RTCA response to QR Network's proposed GAPE reference tariff DAAU

Submission in response to QR Network's proposed
DAAU in relation to a GAPE reference tariff

19 November 2012

Figure 1: An alternative relationship between GTK & AT1 rates approved for UT3

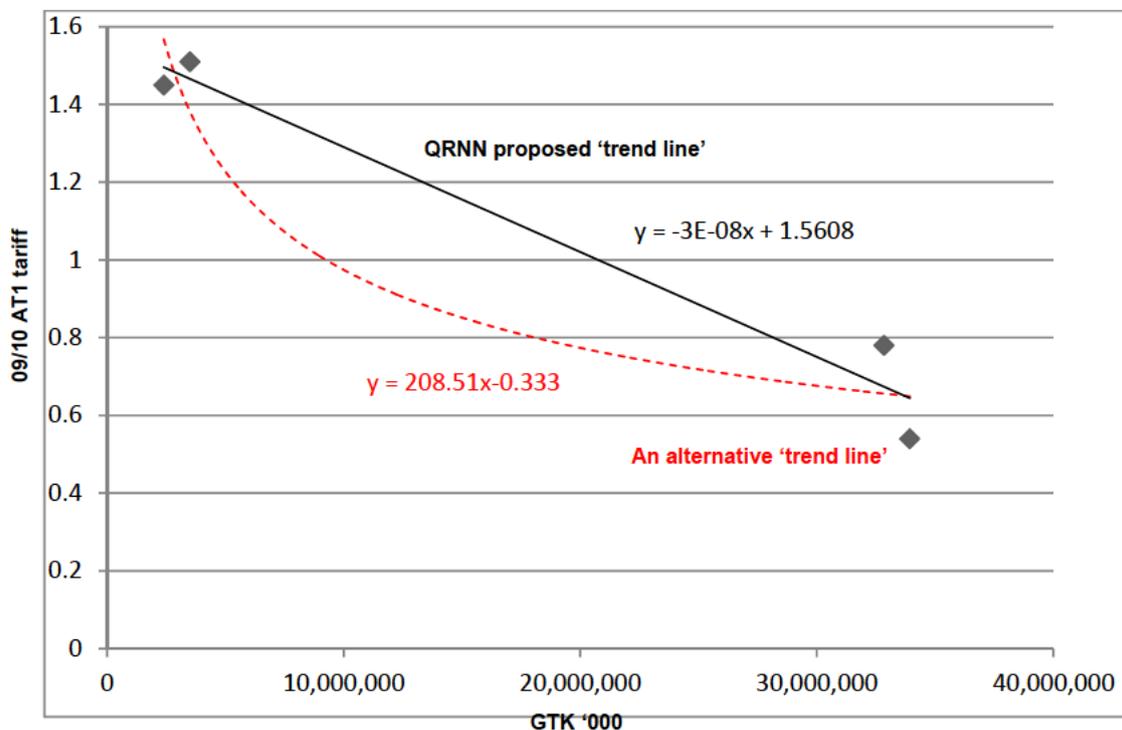
The volume adjustment proposed by QRNN is also overly simplistic. QRNN assumes a simple linear relationship between volumes and maintenance costs, without providing any justification for this assumption. This is illustrated in Figure 5 of the QRNN submission.

The assumption of a linear relationship between volume and costs has a very significant impact on the estimate of incremental maintenance costs. If a non-linear relationship is assumed (as in Figure 1 below), the estimate of maintenance costs per '000gk falls from \$1.22 (as estimated by QRNN) to well below \$1.

RTCA submits that maintenance costs to be included in GAPE reference tariffs cannot simply be inferred from costs associated with brownfield railways, assuming a simple linear relationship between costs and volume (particularly given the very limited number of data points from which to derive any such relationship).
